SAFETY EVALUATION REPORT
OPEN AND CONFIRMATORY ITEM STATUS
HOPE CREEK GENERATING STATION
DOCKET NO. 50-354

<u>ITEM NO.</u>	<u>SER SECTION</u>	<u>SUBJECT</u>
C-14	6.3.5 and 15.9.3	Loss-of-Coolant-Accident Analysis
C-25	7.6.2.4	End-of-Cycle Recirculation Pump Trip
C-37	15.9.3	TMI Item II.K.3.18

SER Confirmatory Item No. 14 (SER Section 6.3.5 and 15.9.3)

Loss-of-Coolant-Accident Analysis

This replace Figure 6.3-4

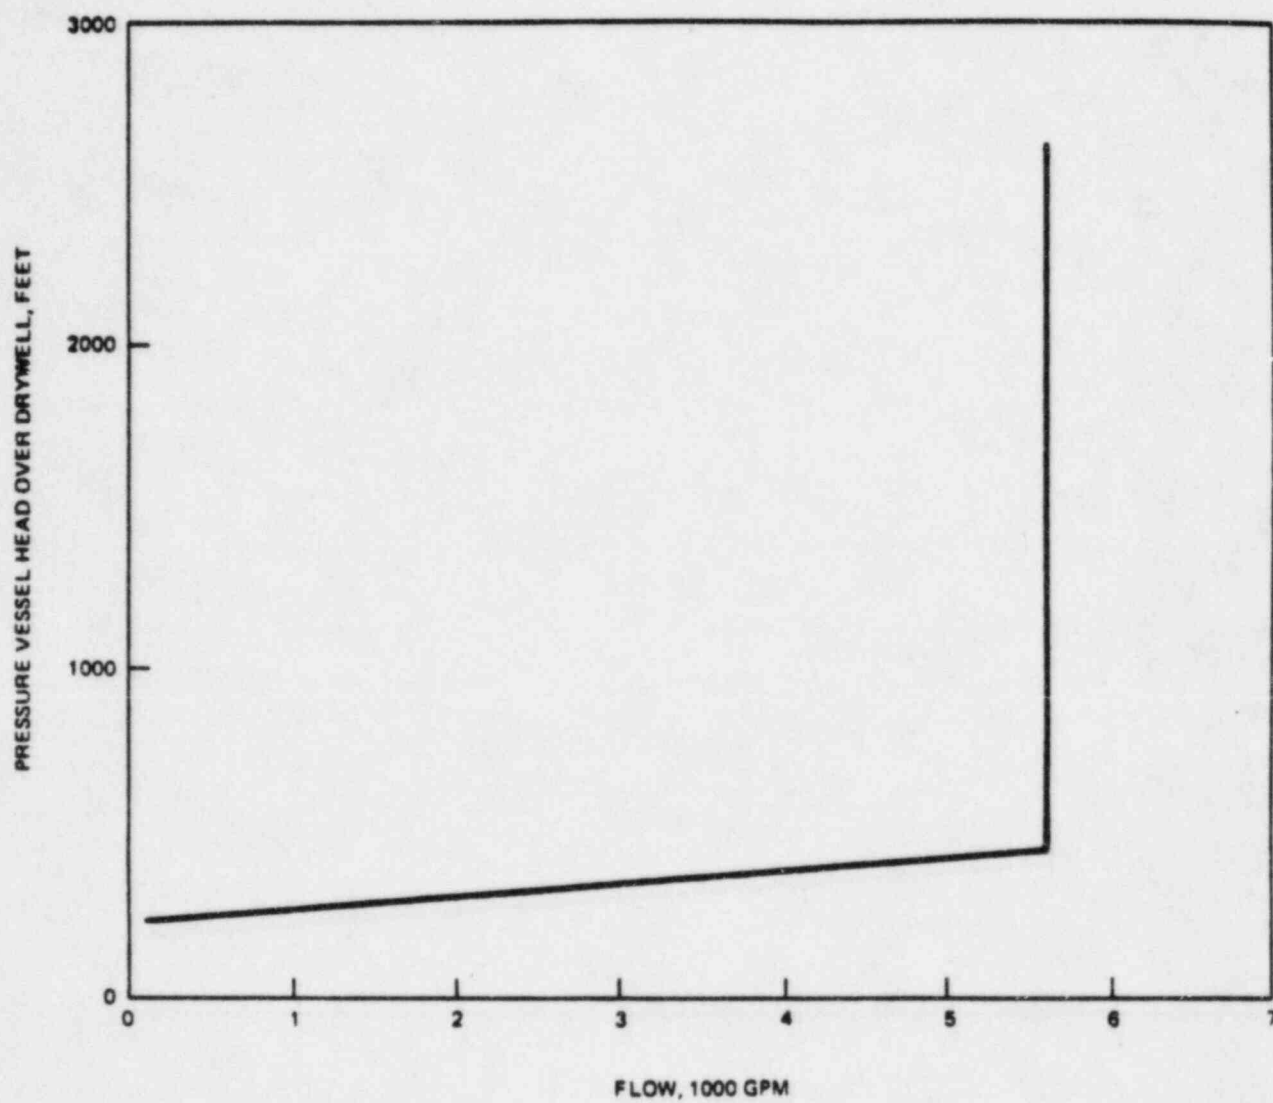
SER ITEM C-14

Title: Peak Cladding Temperature and Maximum Local Oxidation

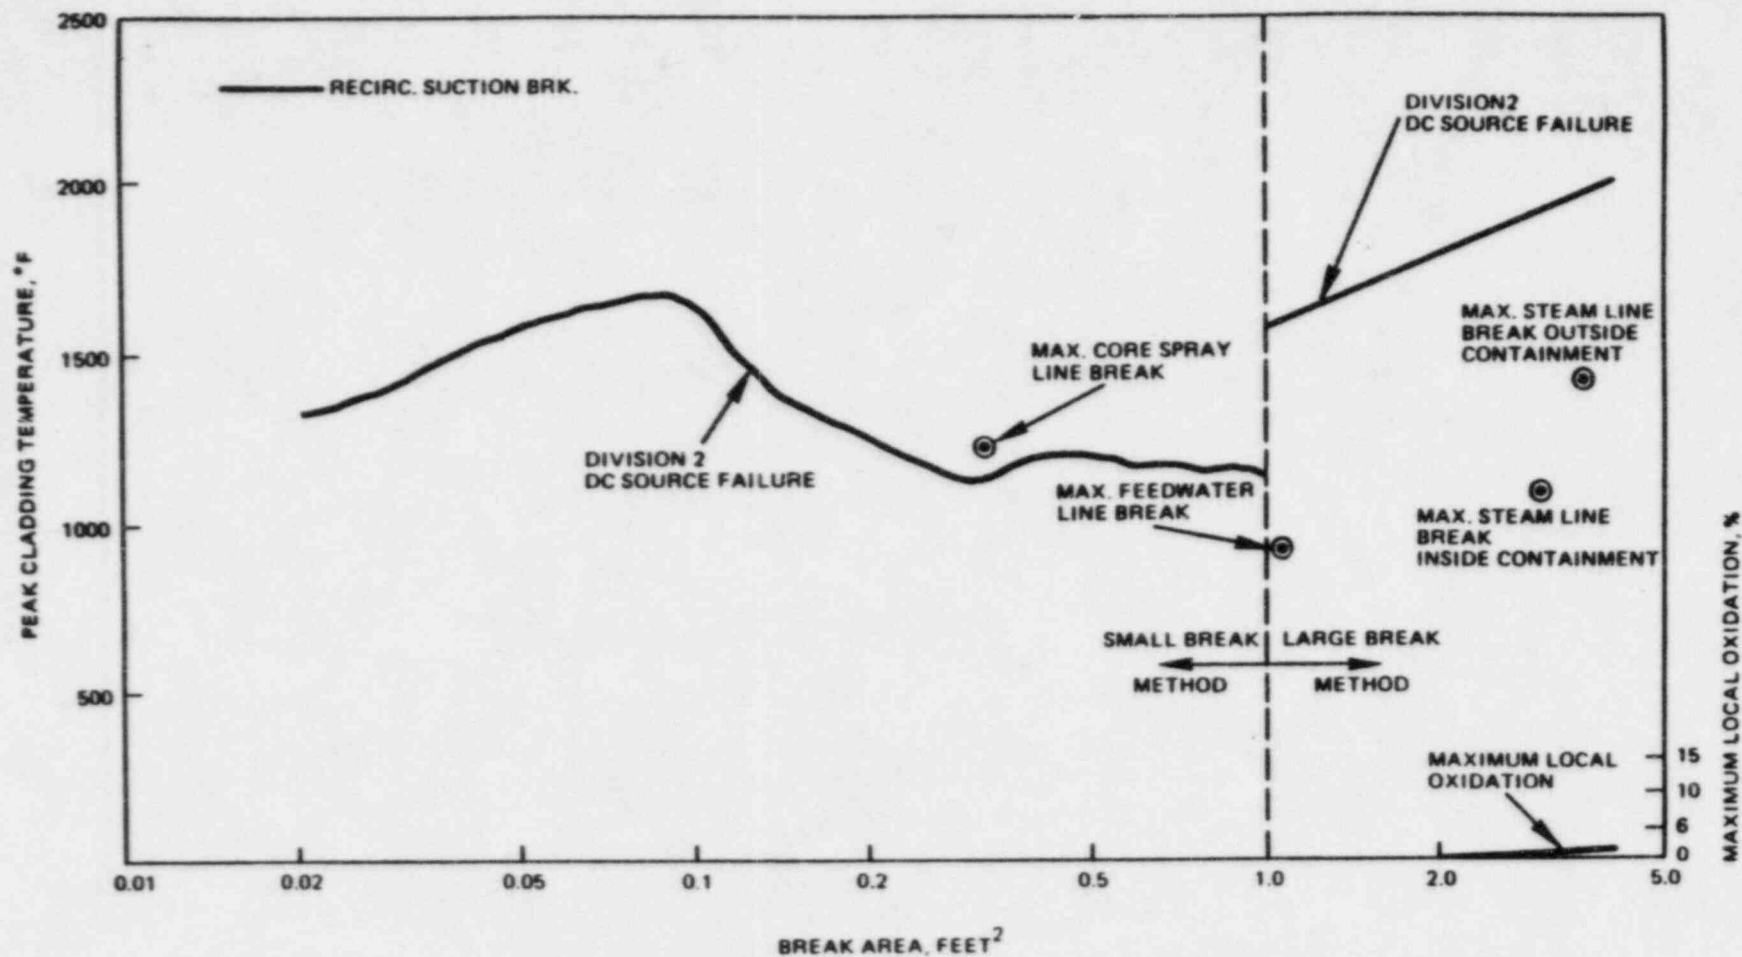
This replaces Figure 6.3-14

SER ITEM C-14

Title: Fuel Rod Convective Heat Transfer Coefficient
vs. Time After Break (Maximum Main Steam
Line Break Inside Containment, Failure of Channel
A DC Source)

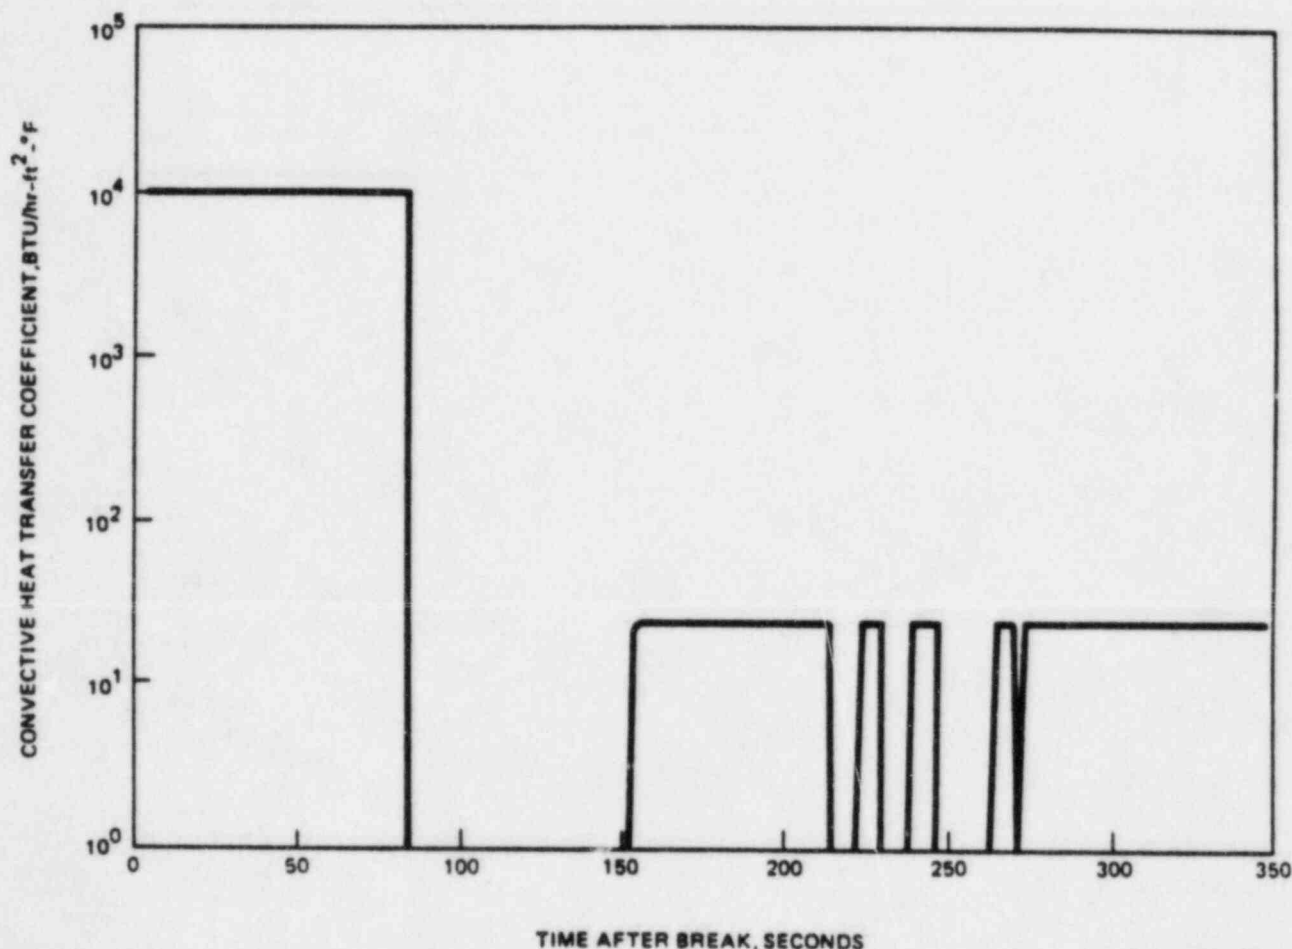
This is to replace Figure 6.3-56.

Title: Peak Cladding Temperature vs. Time After Break (Maximum Main Steam Line Break Inside Containment, Failure of Channel A DC Source)

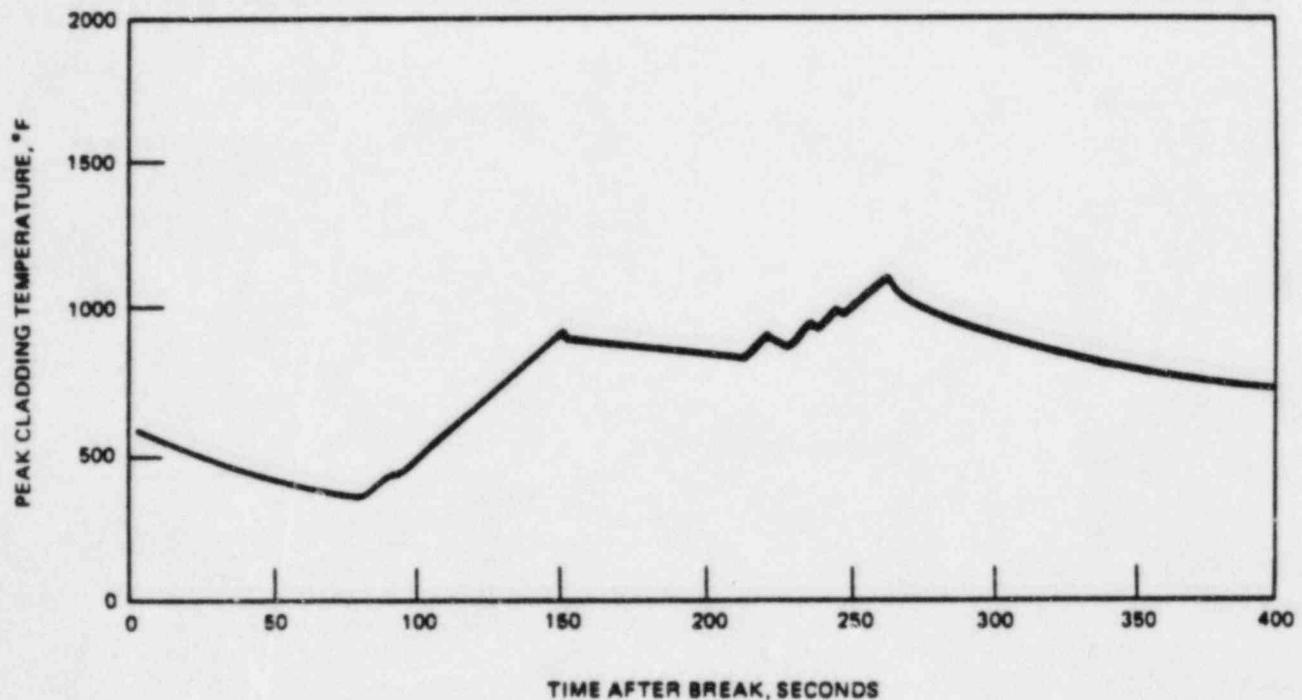
This replaces Figure 6.3-57.

Title: Water Level Inside Shroud vs Time After Break
(Maximum Main Steam Line Break Outside
Containment, Failure of Channel A DC Source)

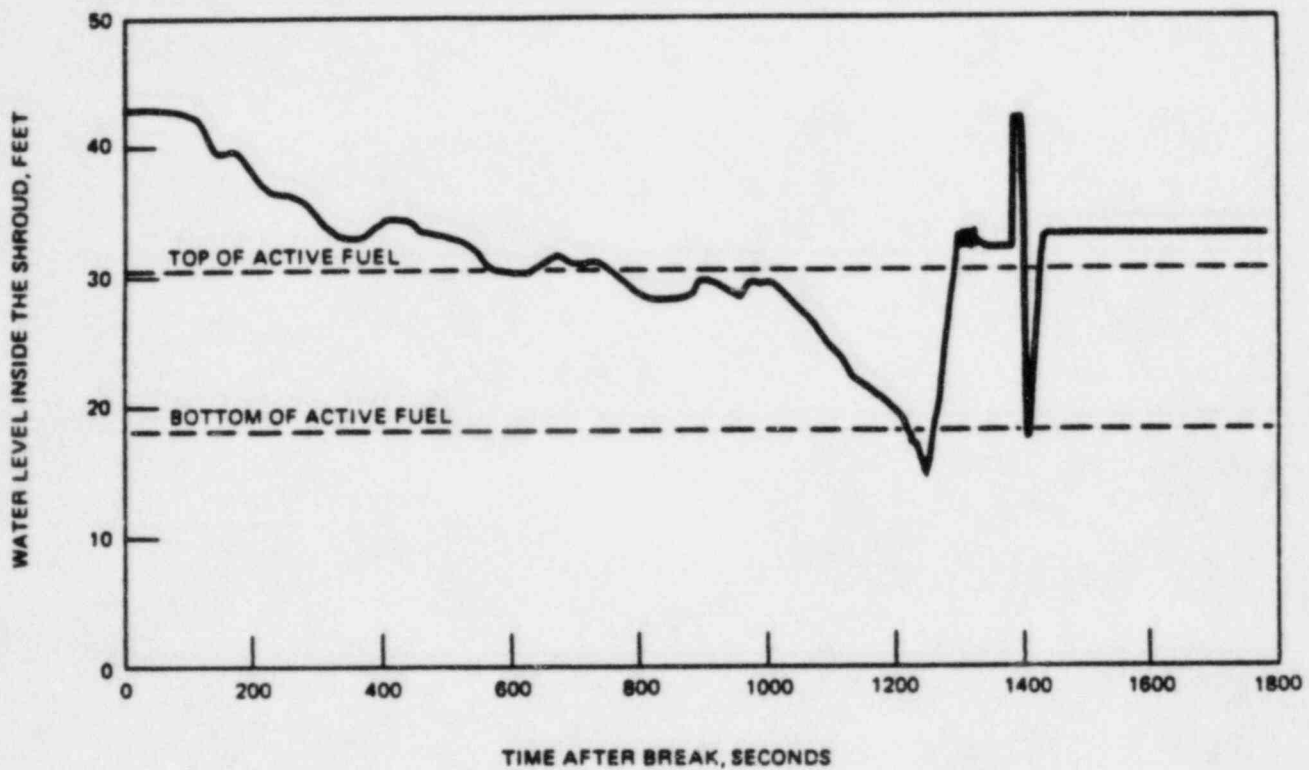
This replaces Figure 6.3-58.

Title: Reactor Vessel Pressure vs Time After Break
(Main Steam Line Break Outside Containment,
Failure of Channel A DC Source)
(Maximum)

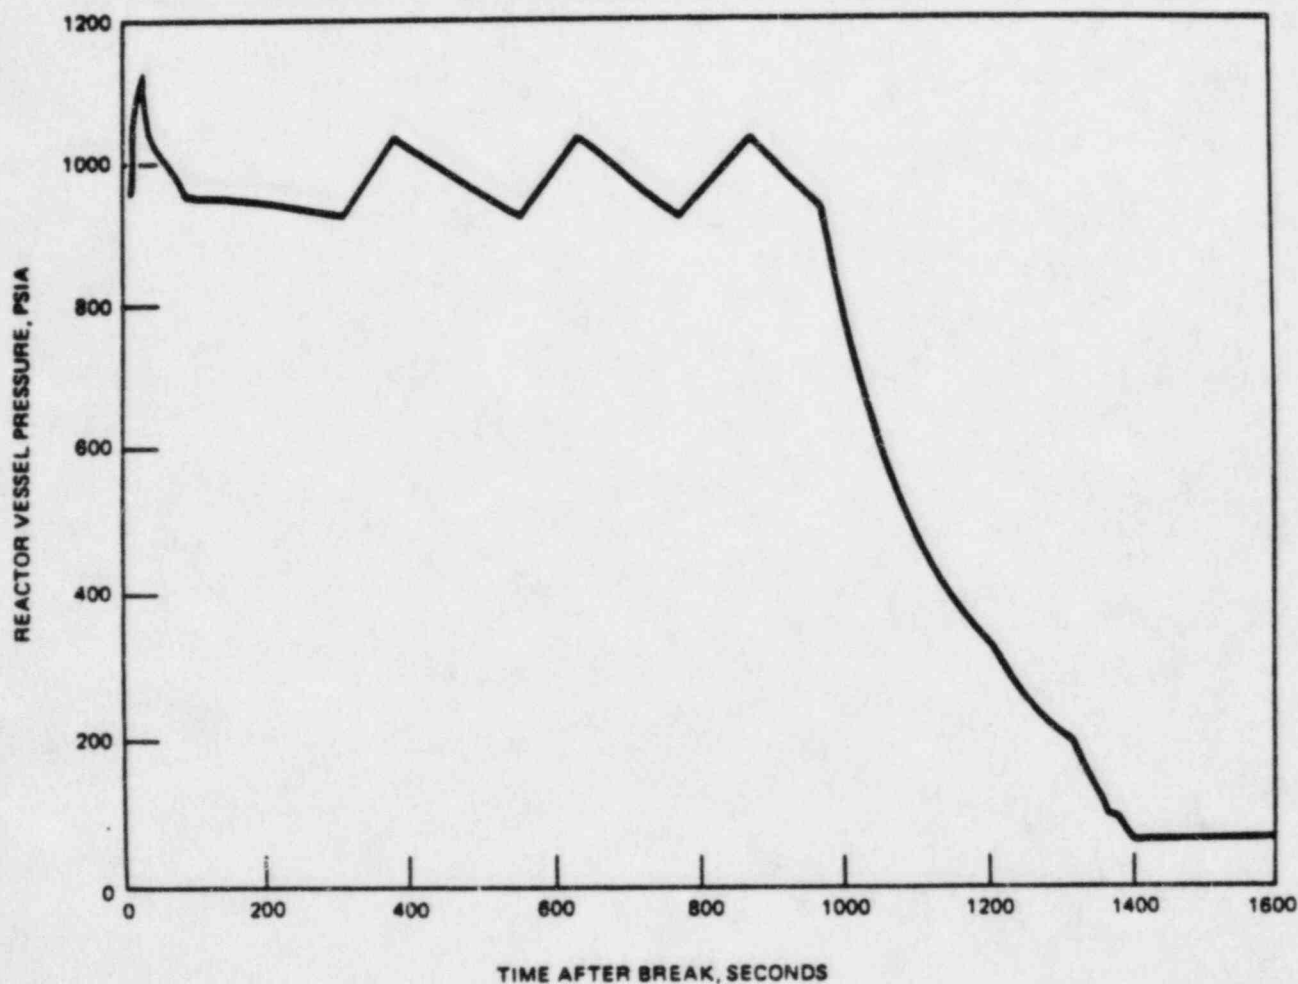
12-3-54
This replaces Figure 6.3-59.

Title: Fuel Rod Convective Heat Transfer Coefficient
vs. Time After Break (Small Break Model)
(Main Steam Line Break Outside Containment,
Failure of Channel A DC Source)

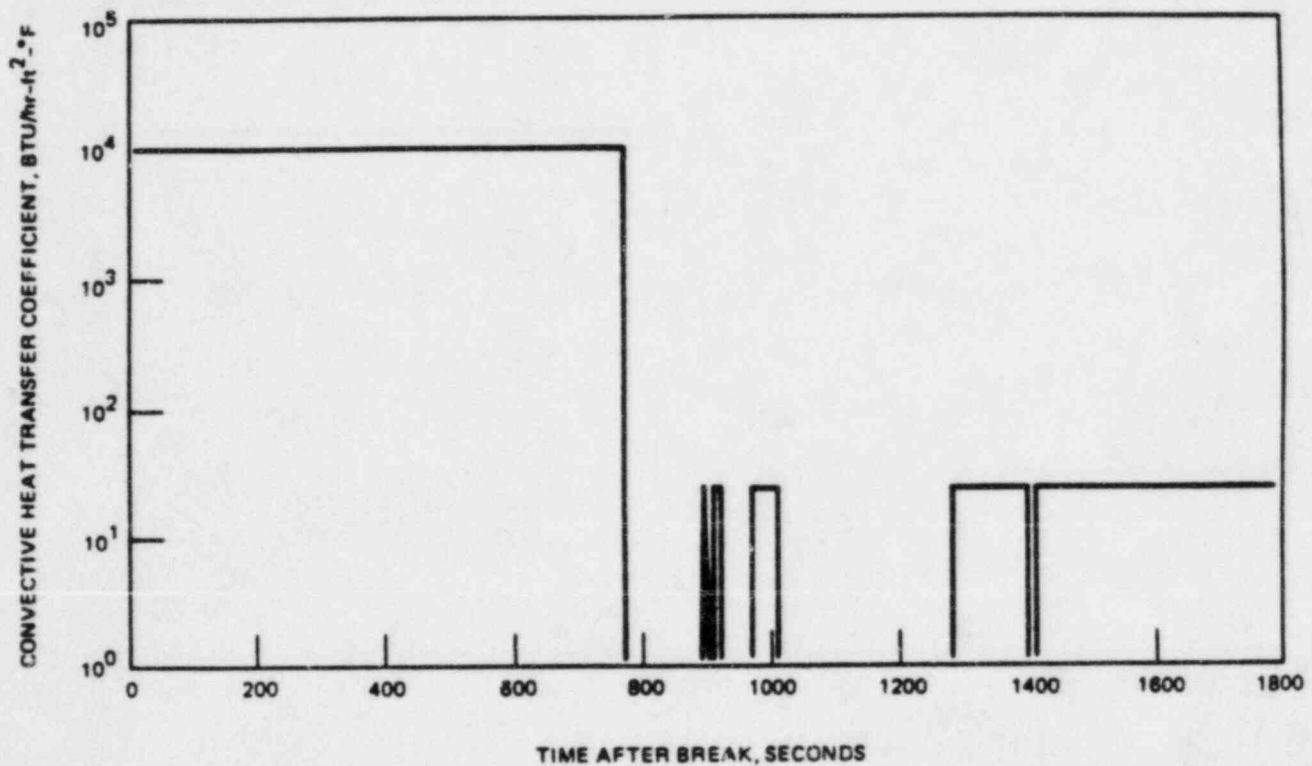
This replaces Figure 6.3-60.

Title: Peak Cladding Temperature vs Time After Break
(Small Break Model) (Maximum Main Steam
Line Break Outside Containment, Failure of
Channel A DC Source)

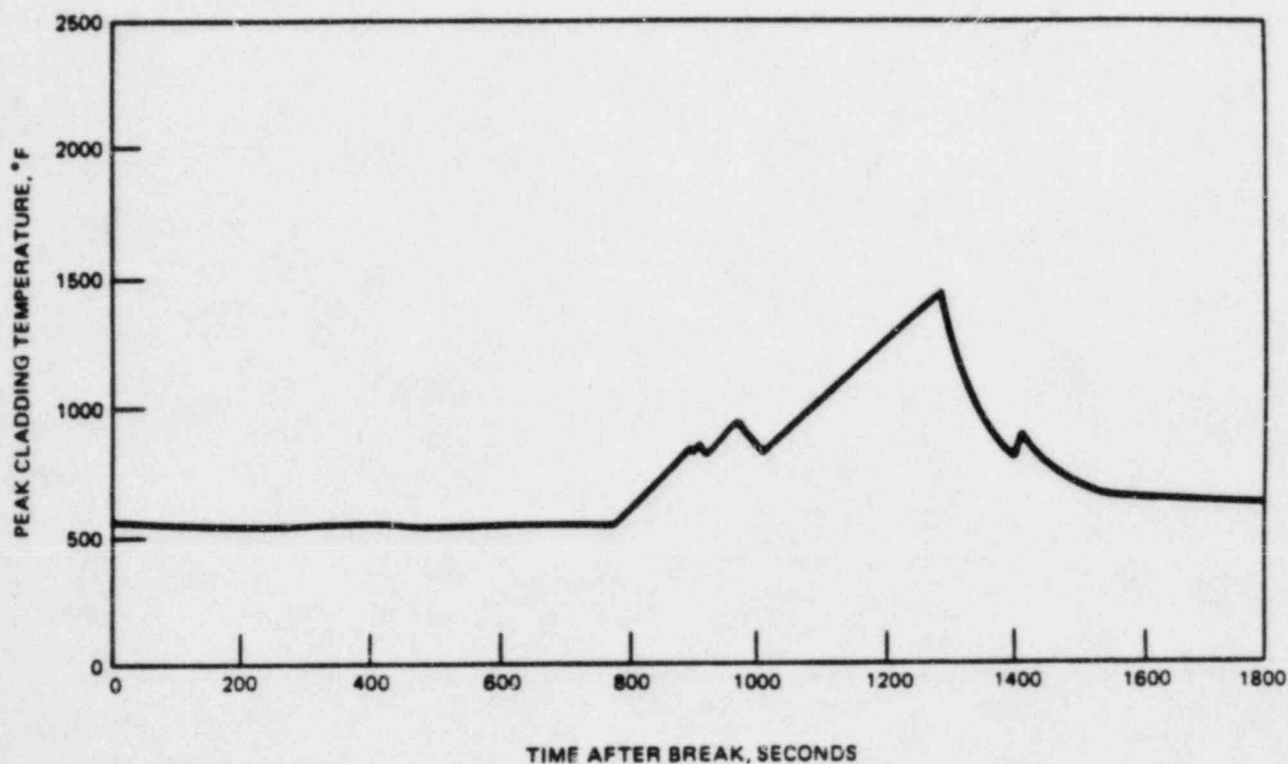
This is new Figure 6.3-61.

Title: Total Time Highest Powered Node Remains Uncovered vs Break Area (Failure of Channel A DC Source)

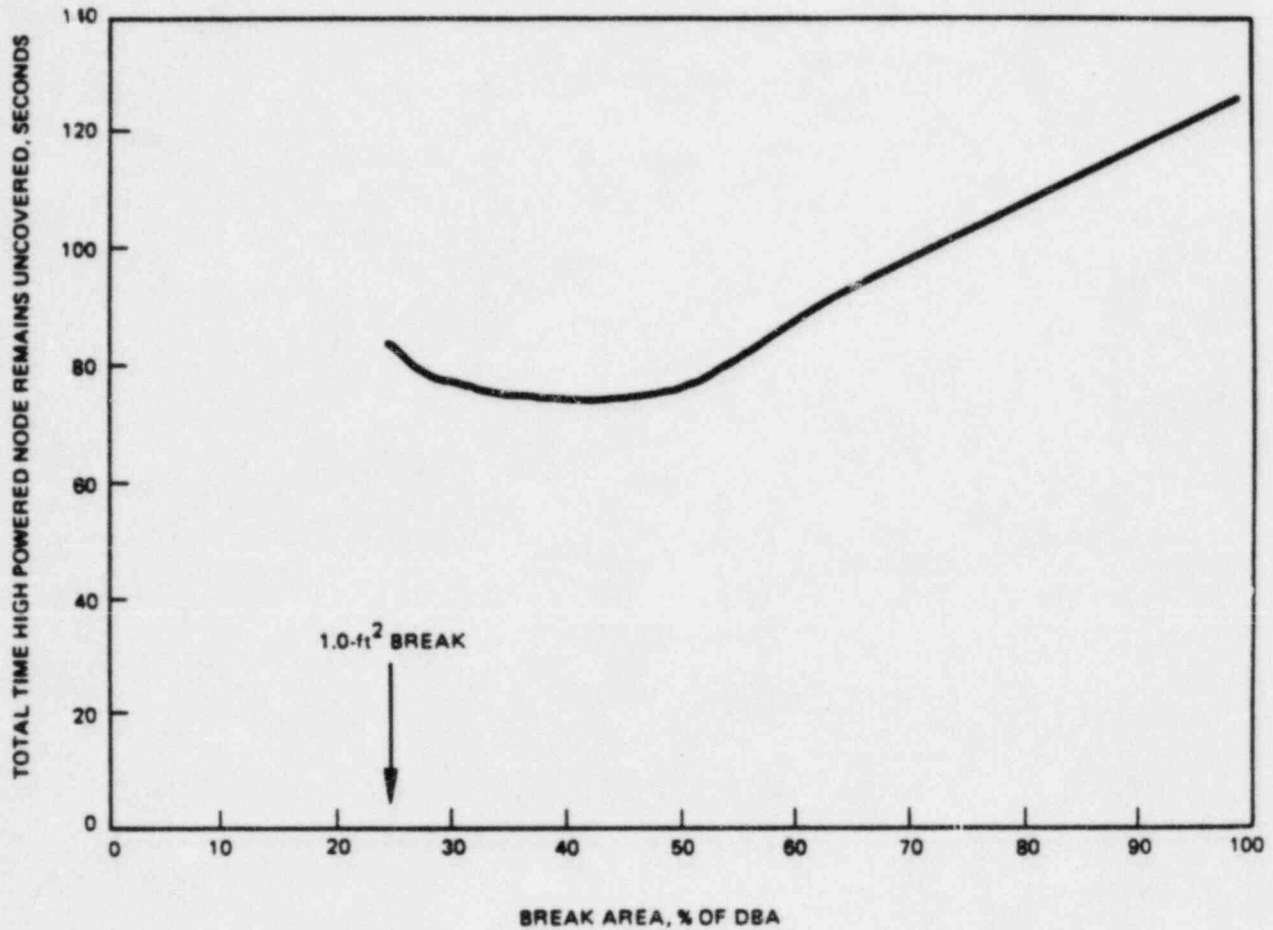
62
 Figure 6.3-~~60~~ shows the variation with break size of the calculated time the hot node remains uncovered. Based on these calculations, the design basis accident (DBA) was determined to be the break that results in the highest calculated peak cladding temperature in the 1.0 ft² to 4.1 ft² region (the largest possible area of a recirculation system line break is 4.1 ft²). Confirmation that this is the most limiting break over the entire break spectrum is shown in Figure 6.3-14.

This is new Figure 6.3-62
